# D'OVIDIO LAW

Re: **CRMC Application 2018-12-037**

**CRMC APPLICATION 2018-12-037  
BOAT LIFT ANALYSIS AND REPORT  
BY STEPHEN NIGHTINGALE**

# Peter A. Alarie Report on Boat Lift CRMC # 2018-12-037

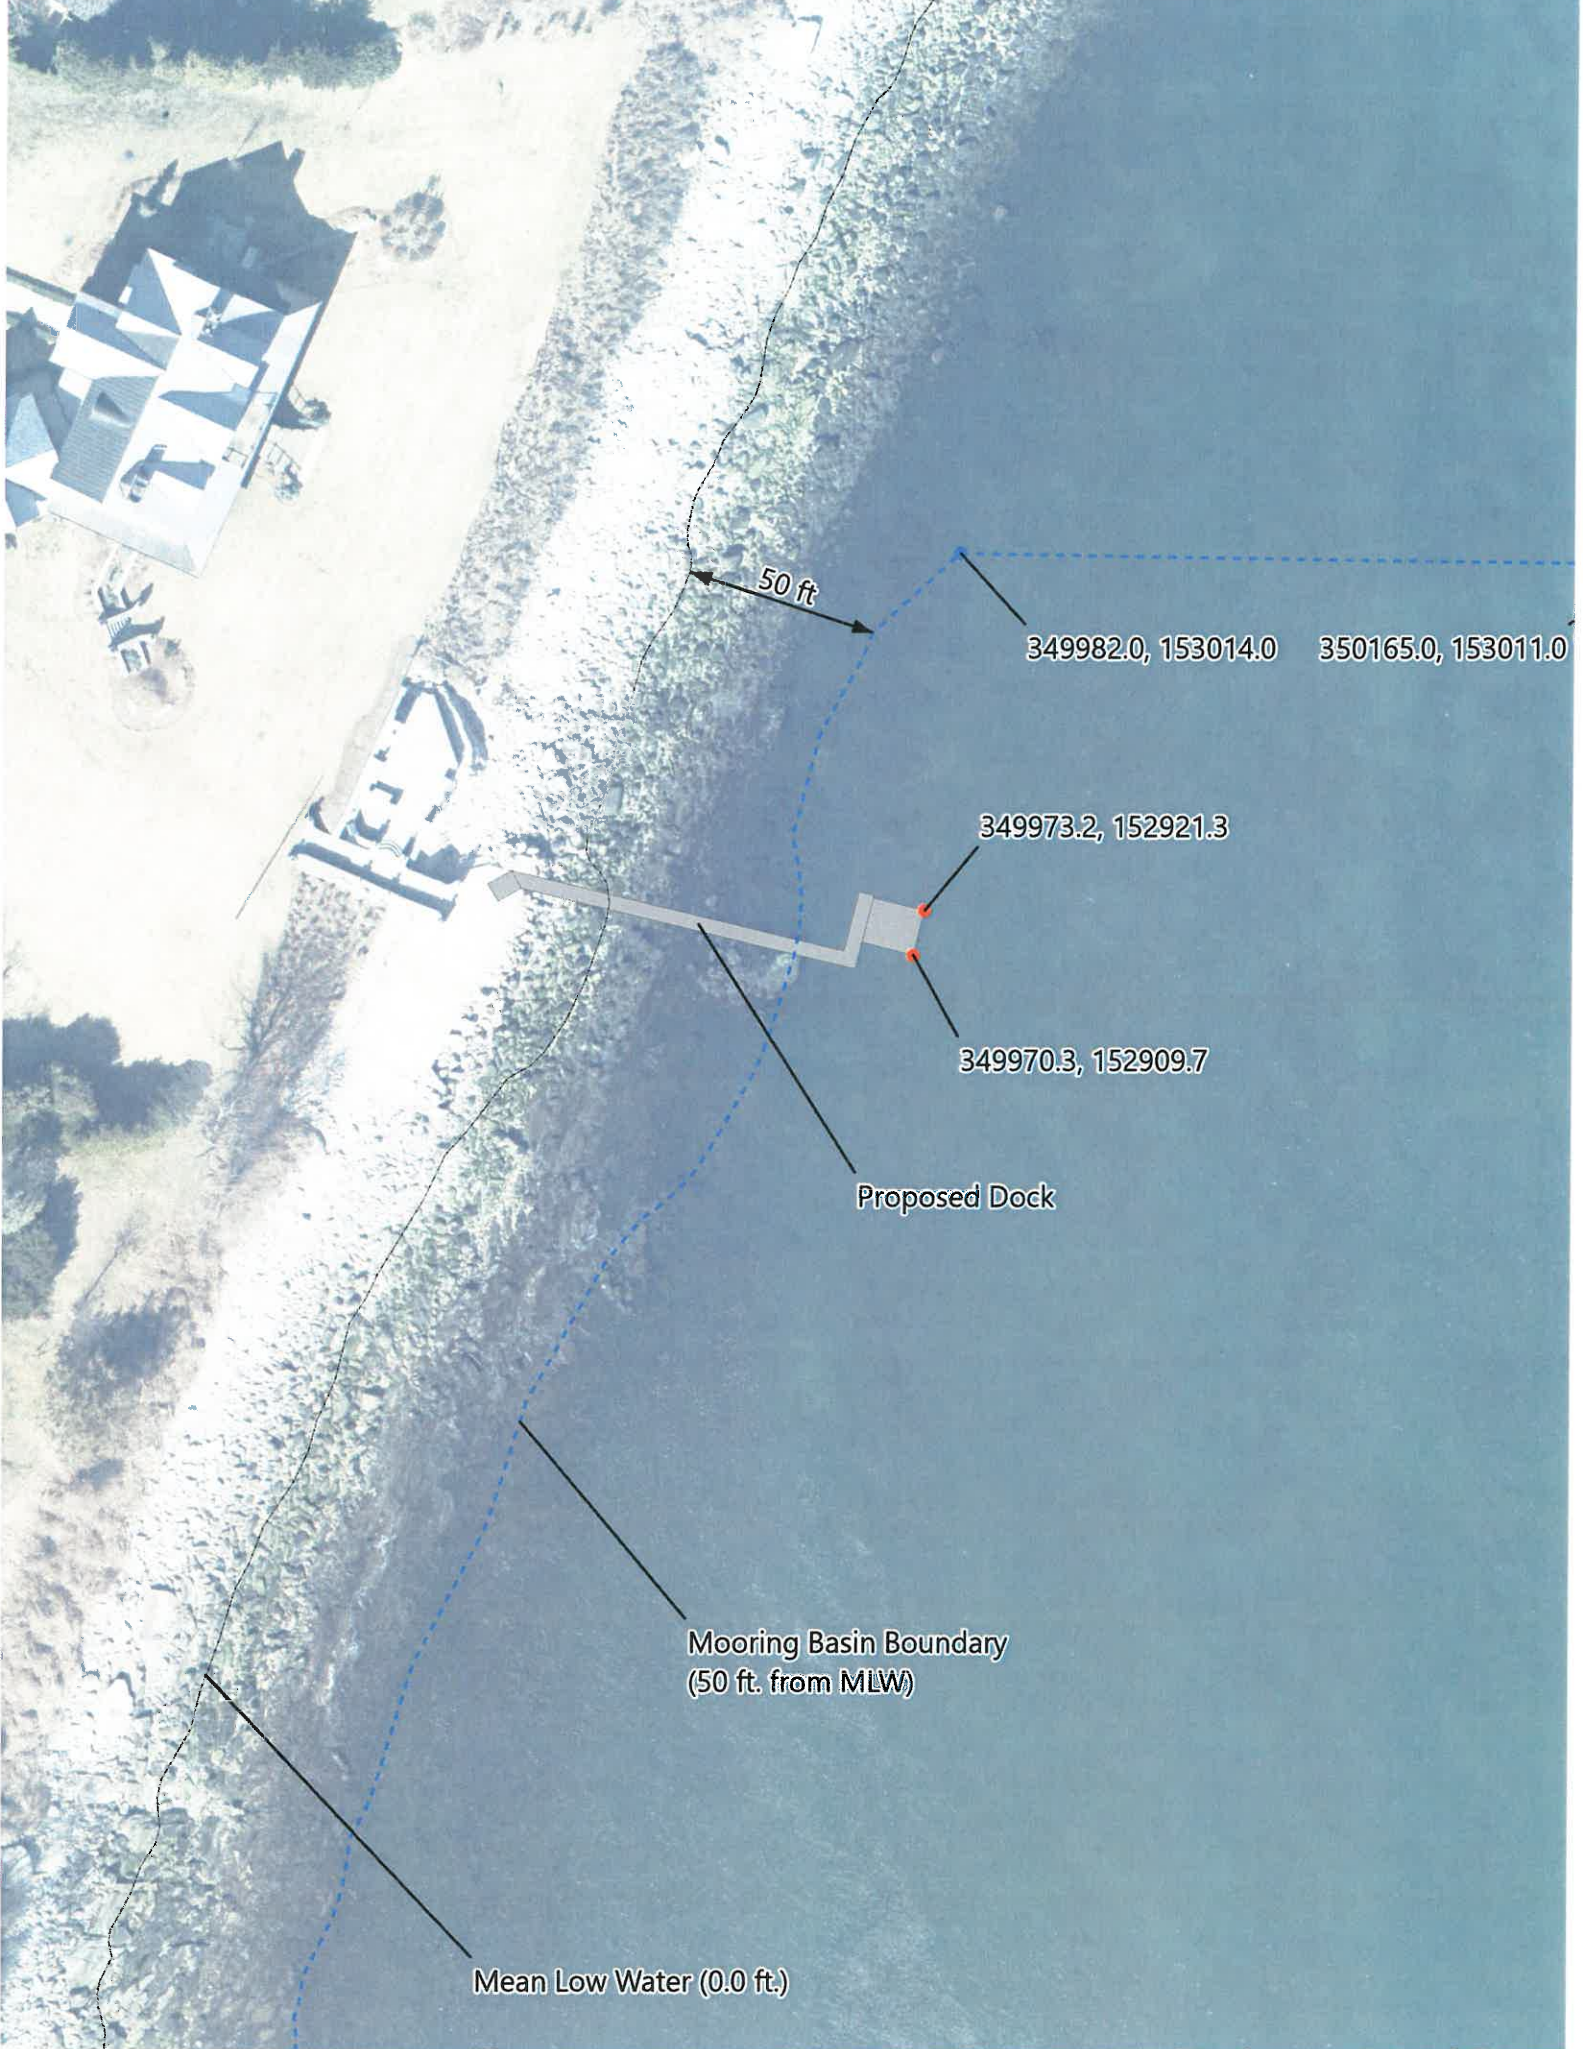
EA mapped the existing bounds of the South Ferry Mooring Basin, located in Town Mooring Area C (Figure 1) using the municipal description stated above. EA has measured the bounds of the mooring basin to be 50 feet seaward of mean low water at the point of the proposed Facility, and as such, would be coincident with the seaward limit of a conformable dock under § 1.3.1.D.11(l). Additionally, EA has mapped the occurrence of moorings and moored vessels in this mooring basin and would use this proof of use by residents of the Town of Narragansett.
